PLANNING COMMISSION MEETING

LOCATION: TOWNSHIP ANNEX, 7527 HIGHLAND ROAD, WHITE LAKE, MI 48383
THURSDAY, SEPTEMBER 05, 2024 – 6:30 PM

**WHITE LAKE TOWNSHIP
PLANNING COMMISSION
AUGUST 15, 2024**

PROJECT	PREPARED FOR	TITLE
GATEWAY CROSSING	GATEWAY CROSSING, LLC	GRADING PLAN
DESIGNED BY:	ST	TOWNSHIP COMMENTS:
DRAWN BY:	DH	MDOT COMMENTS:
CHECKED BY:		REVISION PER
SCALE:	1" = 40'	DATE
JOB NO:	22-029-1	
DATE:	05/30/24	
SHEET NO.	6

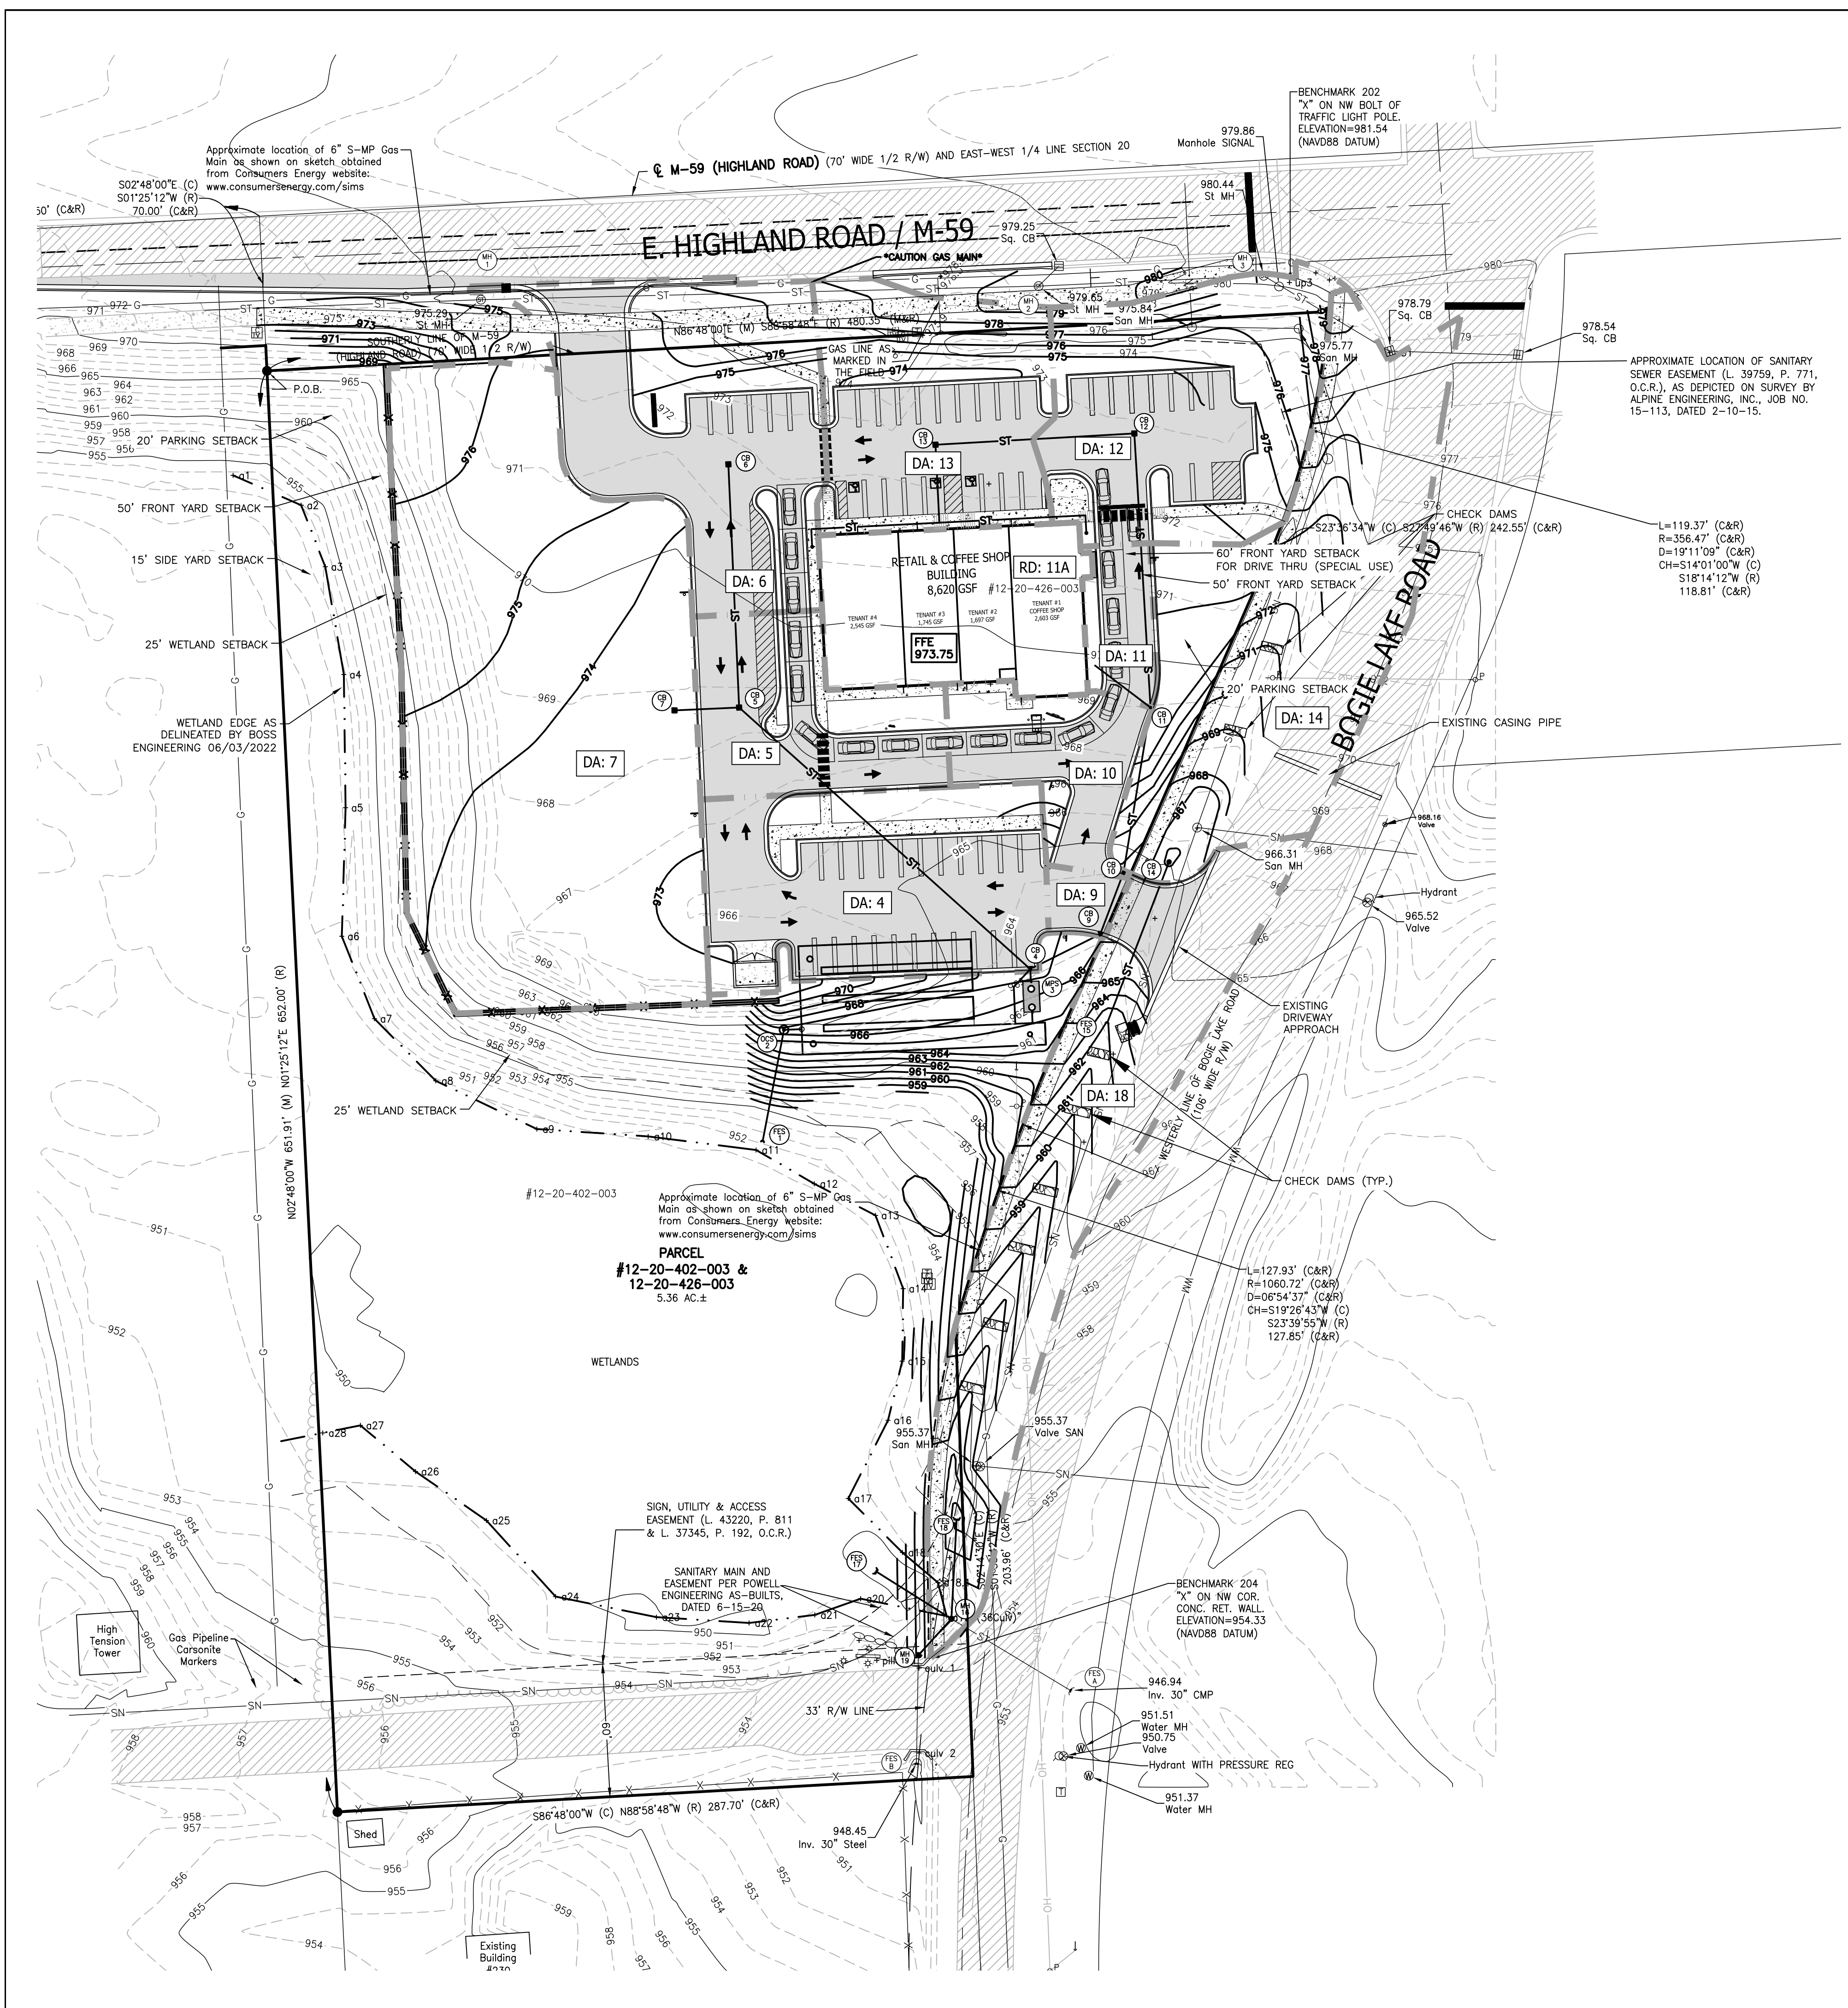
11. *Sheet 6- Show locations of all watermain and sanitary sewer structures and provide their rim elevations on this sheet.* **Comment addressed. FG/rim elevations for watermain and sanitary sewer have now been shown on grading plan.**

5. *Sheet 6- Provide underground detention inspection MH rim elevations on this plan sheet. There is a concern that there will be insufficient cover over the detention pipes. At a minimum, per Table 1 on Sheet 14, 15" minimum cover is required over a 120" diameter pipe for non-vehicle loading areas. There is also the concern that due to the steep grades in the non-paved area that there will be insufficient cover over the pipes. In addition, additional cover would be required in areas where the detention pipes are shown under the parking area based on axle loading (see Contech details on Sheet 14). Please demonstrate that there will be sufficient cover for all of the underground detention*

DESIGNED BY:	ST
DRAWN BY:	JS
CHECKED BY:	
SCALE:	1" = 40'
JOB NO:	22-029-1
DATE:	05/30/24
SHEET NO.	7

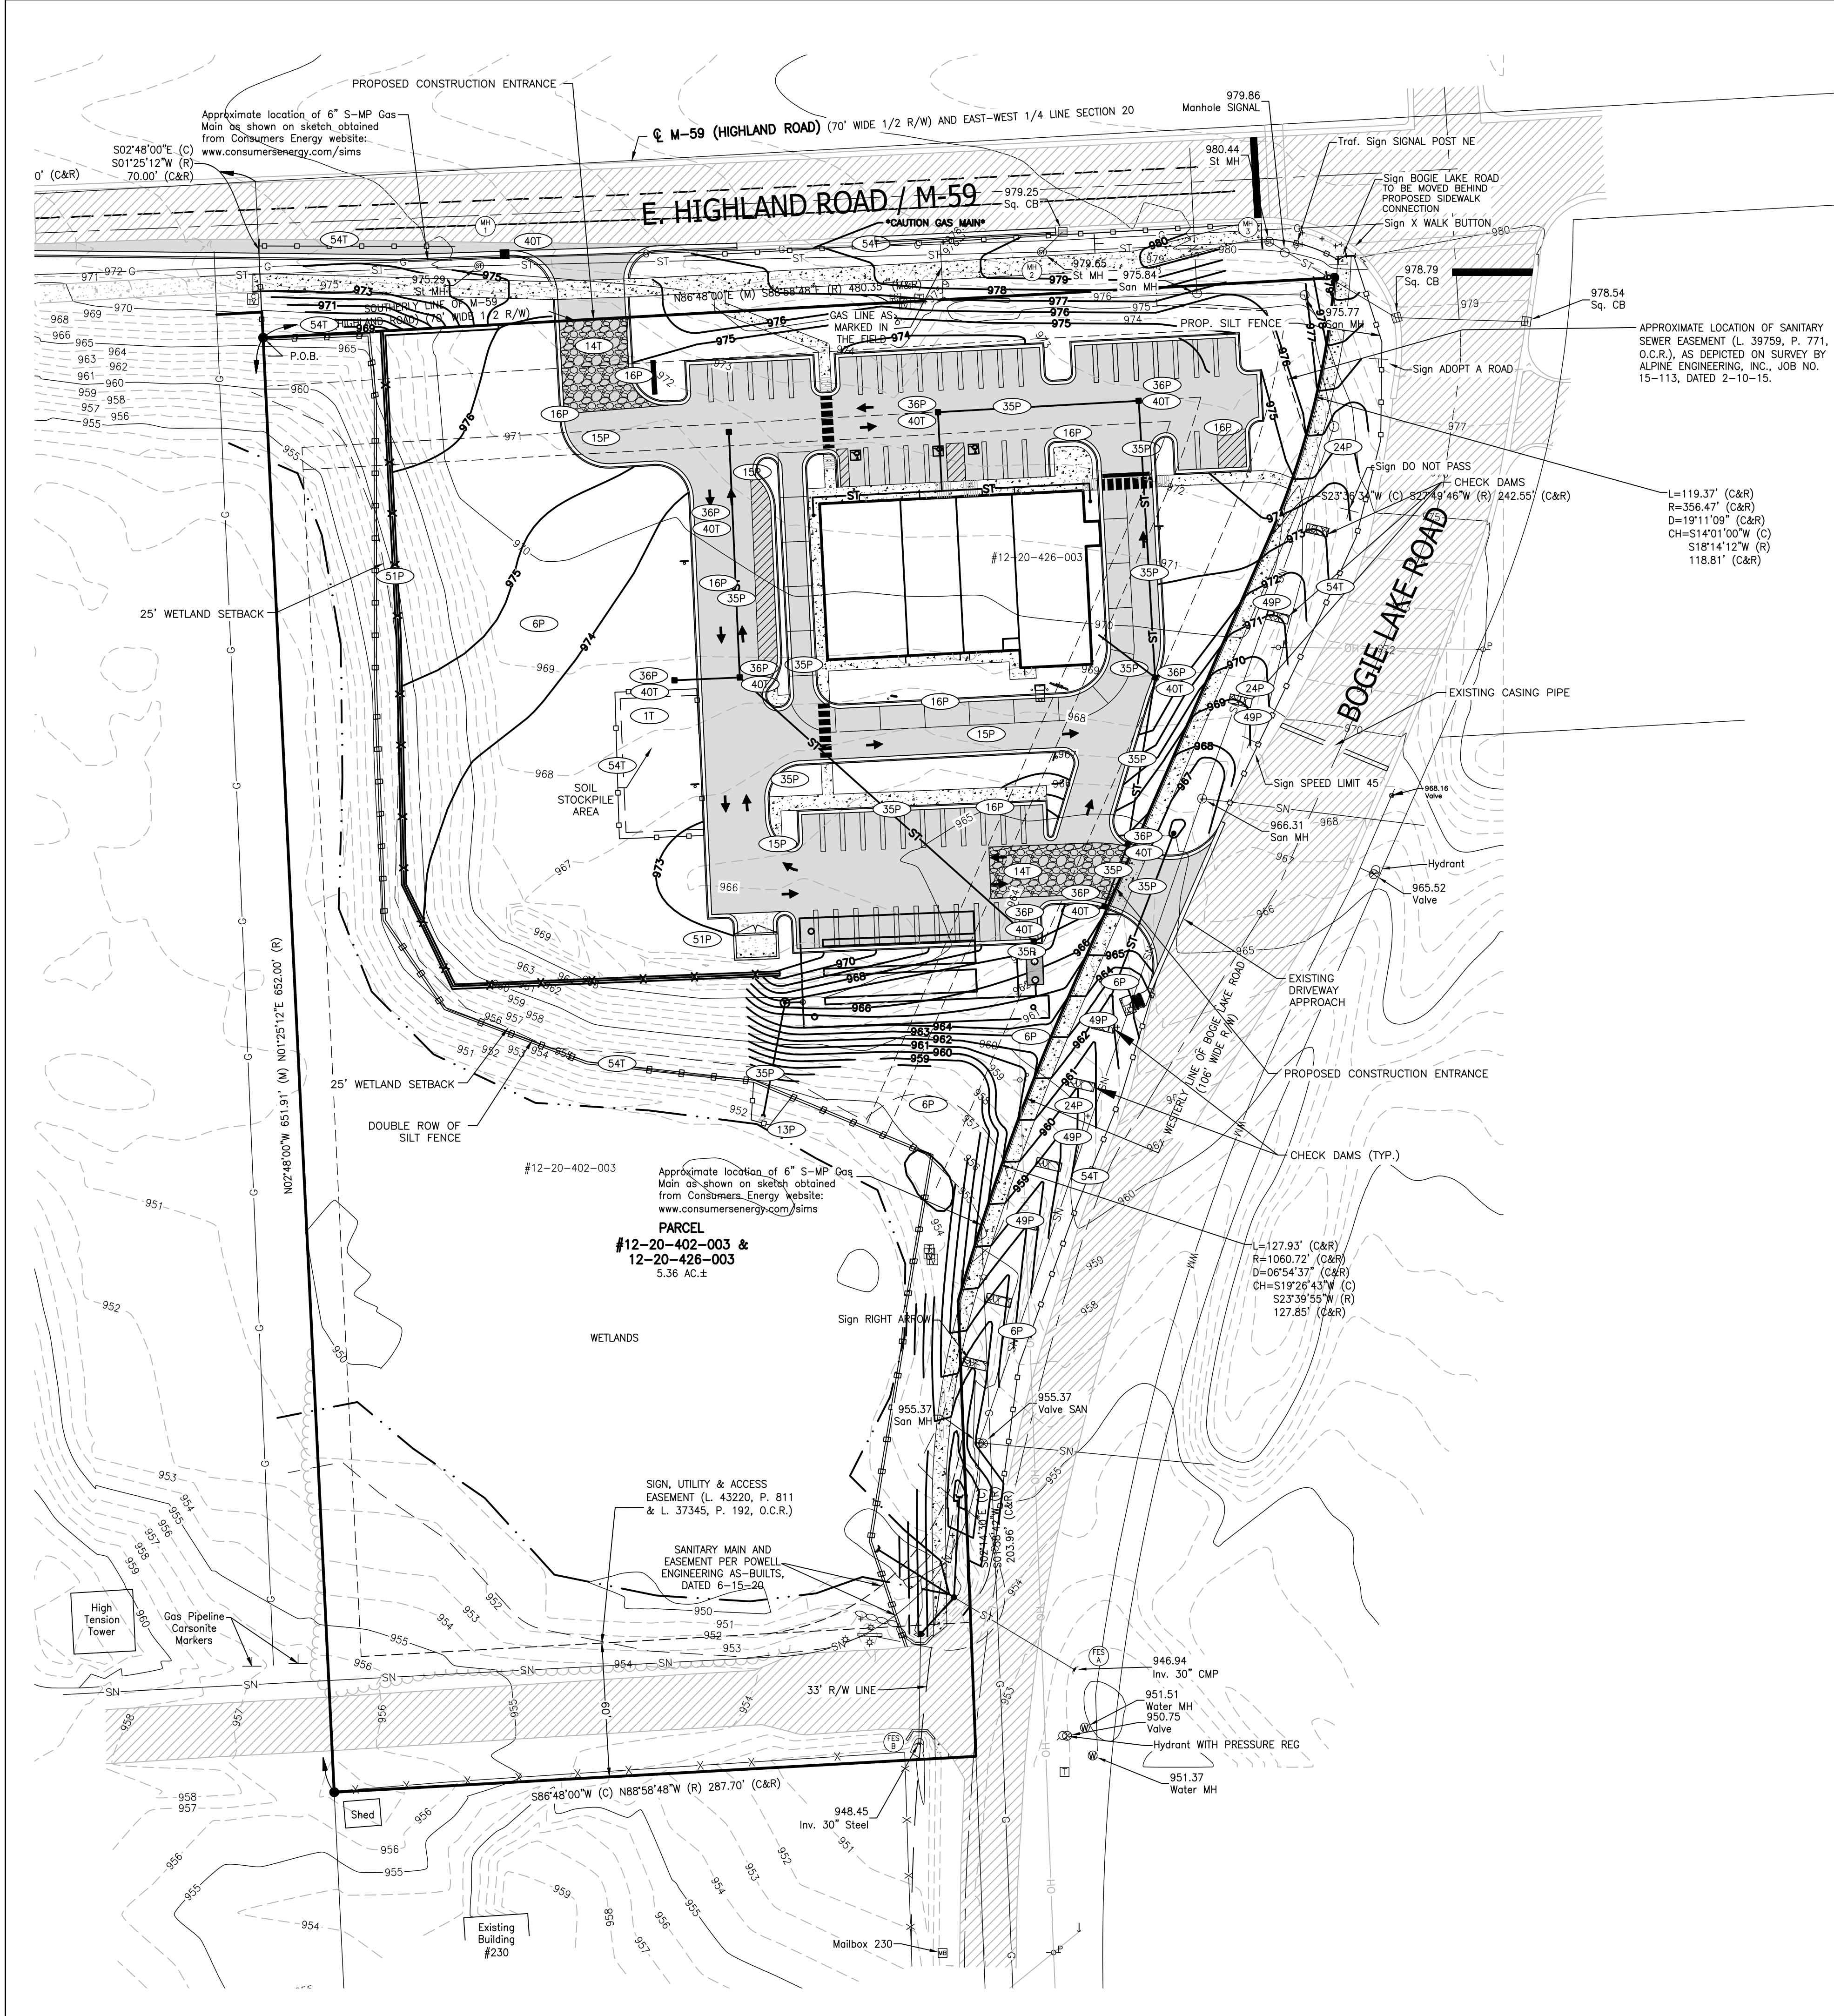
6. *Sheet 7- Stormwater Narrative- Second paragraph- Second to last line- Correct pipe size from 24” to 30”.* **Comment addressed. Pipe size has been corrected.**

7. *Sheet 7- Drainage Area Table lists Drainage Area 2- Although negligible in terms of C_{AVG} calculations, please show this area on the drainage map on this sheet.* **Comment addressed. Drainage Area 2 has been removed from the Drainage Area Table.**

8. *Sheet 7- Note at bottom of sheet- “See Sheet 9 for basin detail...”- Correct Sheet number to Sheet 13.* **Comment addressed. Note has been updated.**
